10CFR Part 21 Formal Notification: P21-06032020, Rev. 1

Subject: Failures of Size 1 and 2 Freedom Series Auxiliary Contacts

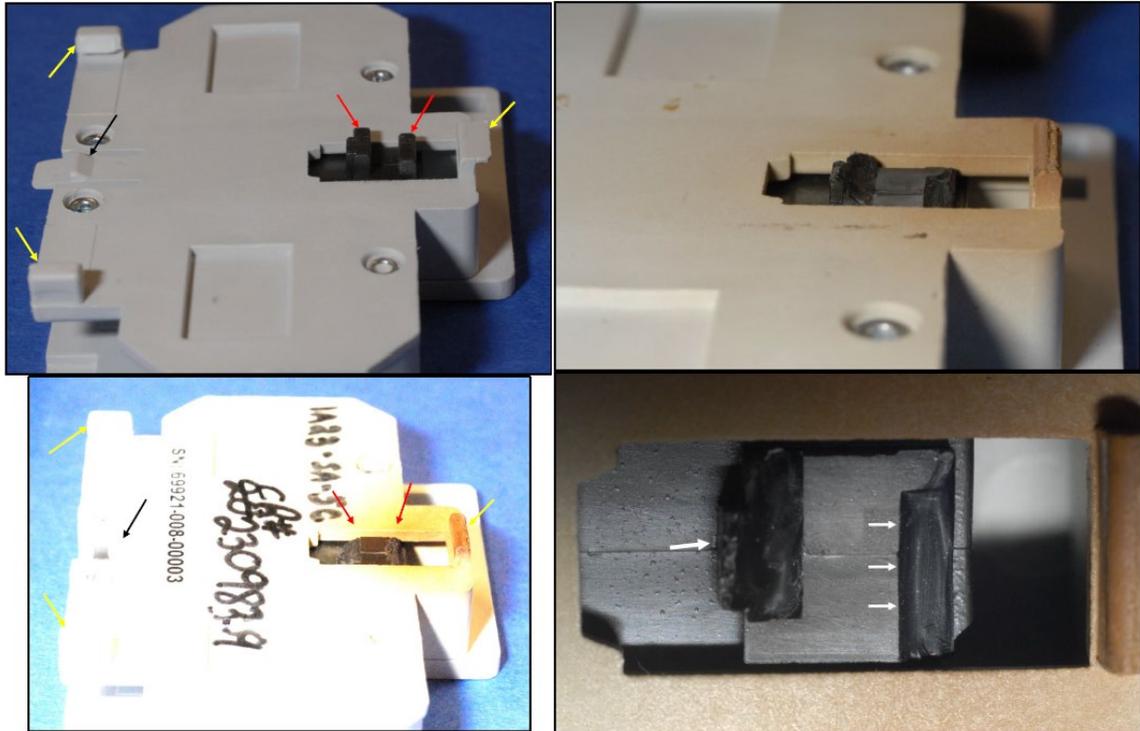
The nature of the defect is the pre-mature aging of the component within the auxiliary contact mechanism that is adjacent to the operating coil. The starter coil is potentially being subjected to voltages of a nature that elevates the temperature within the starter adjacent to the auxiliary contacts.

The root cause of the degraded component is due to the increased voltage and the overall temperature of the starter coil at the elevated voltage. This elevated voltage and temperature has degraded the mechanism of the auxiliary contact operator to a point to which it has become separated from the parent component. See example figures below.

It is recommended that the starters and coils be replaced in the applications where the units are being operated in a continuous duty application. It is also recommended that the control transformer be replaced with a true 4:1 ratio transformer. Paragon/NLI has developed a true 4:1 ratio transformer that will provide additional mitigation of this potential over-voltage condition. Replacing the transformer with a true 4:1 ratio, reduces the control voltage that is being applied to the control circuit in a manner that will not prevent the unit from providing a sufficient voltage during a degraded voltage condition, and also will not subject the components to a voltage above the ratings when the supply voltage is operated above the nominal 480 VAC bus voltage.
